MONA OFFSHORE WIND PROJECT

Response to Martyn and Margaret Hussey D3 Submission

Document Reference: S_D4_25

Table 2.1: REP3-110 - Martyn and Margaret Hussey

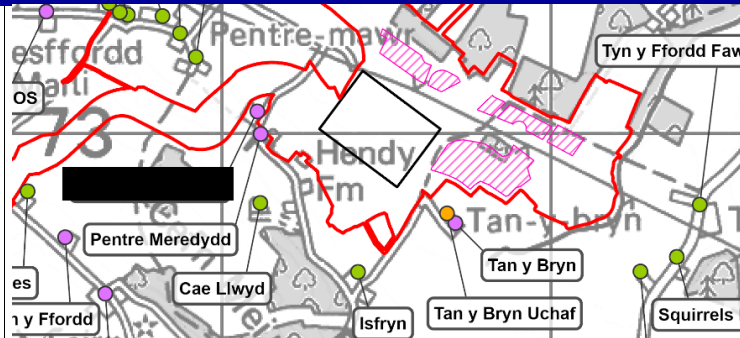
REP3-110.6	<p>Below is part of the drawing number as referenced by applicant with temporary construction compounds indicated by pink cross hatched areas, the closest to [REDACTED] being top centre of this drawing by the wording Mawr</p>	<p>The Applicant notes that a joint bay is unlikely to be sited immediately to the rear of Tyddyn Meredydd. However, the updated assessment has included a joint bay sited within close proximity to Tyddyn Meredydd to represent a worst-case scenario.</p>

It appears from this drawing combined with the responses made by the applicant at deadline 2 and the statements in APP-179 that in assessing the noise impacts on [REDACTED] the distance used in the modelling (which is a significant influencer) was from the nearest temporary construction compound to the boundary of our property.

The Applicant confirms that the updated modelling of joint bay construction works has assumed a realistic worst case scenario that joint bay construction works will not be undertaken at night for the purposes of the assessment, although the operation of pumps to dewater joint bay excavations are assumed to be operating 24 hours a day and this reflected in the updated assessment. Also, the updated modelling has assumed a realistic worst case scenario that no trenchless techniques works are planned to be undertaken at night for the purposes of the assessment, aside from those at landfall and in the vicinity of Gwyrch Wood.

A 2.5m high earth bund along the Onshore Cable Corridor boundary has also been included within the onshore construction noise model. This is in accordance with the indicative onshore cable corridor cross-sectional layout in Appendix to Response to Hearing Action Point: Indicative onshore cable corridor crossing section and trenchless technique crossing long-section (S_D1_5.6) submitted at Deadline 1 [APP-010].

However, no other acoustic barriers have been modelled in the assessment. The Applicant refers to its response to REP1-086.8 (REP-078) in which it was noted the 2.4m high barriers around temporary construction compounds referenced in paragraph 1.5.1.7 of ES Volume 7 Annex 9.2 (AP-072) were removed from the construction noise model.

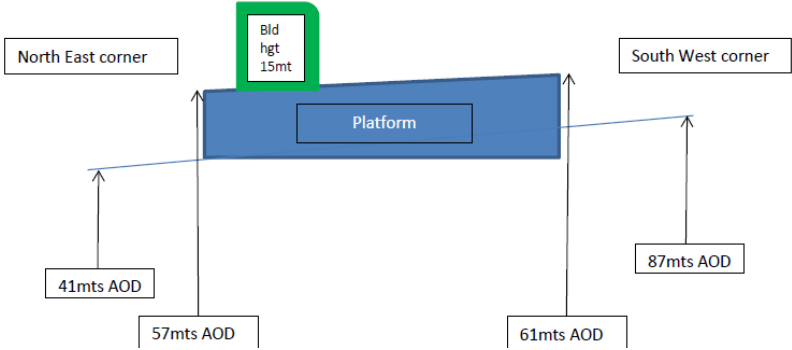
However this does not really answer the question as to worst case scenario being used in visualisations, since the applicant states that the AOD of the proposed substation site is currently 87mts at highest point and 41mts at lowest point

If the existing land is 41mts AOD at lowest point towards North Eastern corner and the platform slopes from 61mts to 57mts for hydrological reasons (drainage) and the lower height of the platform is assumed to be towards the North Eastern corner as indicative drawings show and information given to land users then:-

As stated above in REP3-110.24, the existing ground level low point of 41 m AOD is not located within the onshore substation platform itself, but rather to the area located north, within Work No 23.

The existing ground level low point within Work No. 22 (the onshore substation platform) is approximately 54 m AOD. The Applicant has provided indicative onshore substation cross-section figures (S_D4_25.1) to illustrate this. The information presented on the onshore substation cross-sections has been derived from LiDAR and topographical survey data and early construction feasibility work undertaken by the Applicant.

The finished ground level of the onshore substation platform is anticipated to be between 57 and 61 m AOD. The onshore substation buildings will be built on top of this, with a maximum height of 15 m. The lightning masts will also be built on top of the platform. The visualisations have been produced using these maximum design scenario parameters.
